Application No. DA2021/2600

43, 45 & 49 Warriewood Road, Warriewood

Description: Subdivision of land, creek line works and the construction of two (2) residential flat buildings

Re: Submission
Application No. DA2021/2600
Address: Lot 1 and Lot 2 DP 349085 and Lot DP 972209
43, 45 & 49 Warriewood Road, Warriewood
Description: Subdivision of land, creek line works and the construction of two (2) residential flat buildings

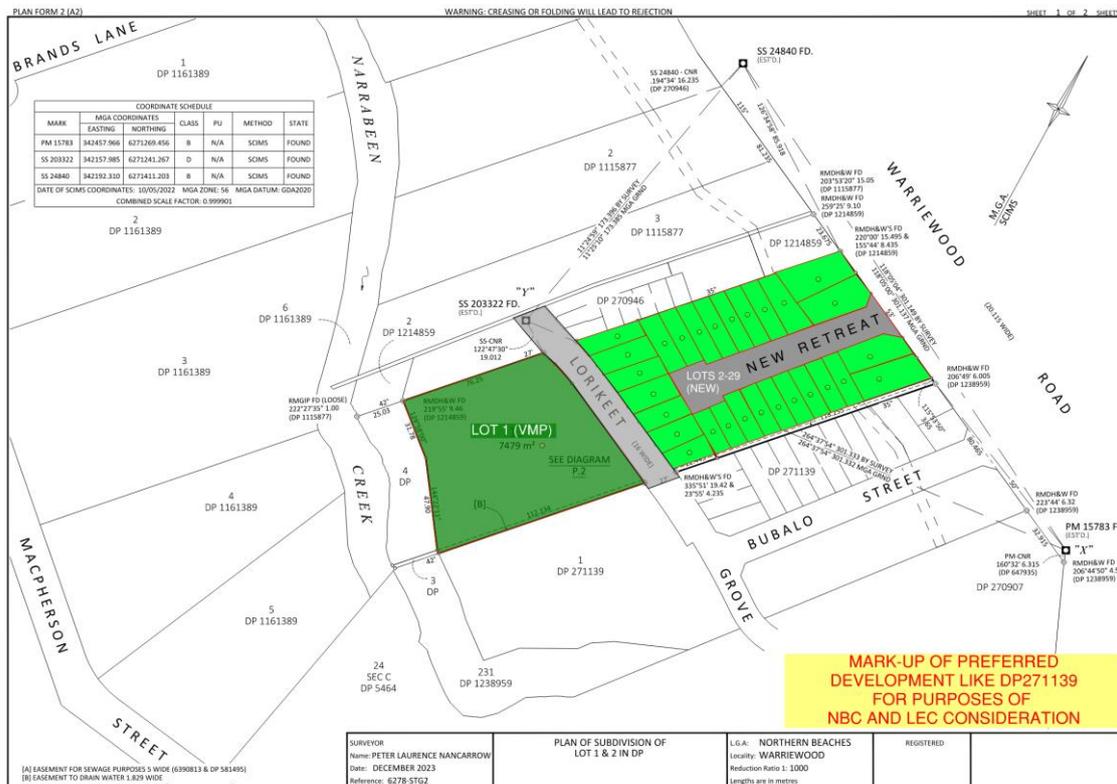
5. STAKEHOLDER ENGAGEMENT. The previous S34 that was held still does not consider the suggestions by the Community to reproduce another development like DP271139. To assist this, please refer to the below mark-up showing preferred concept for consideration and request again for the LEC to support the Community's preference of acceptable development for the area.
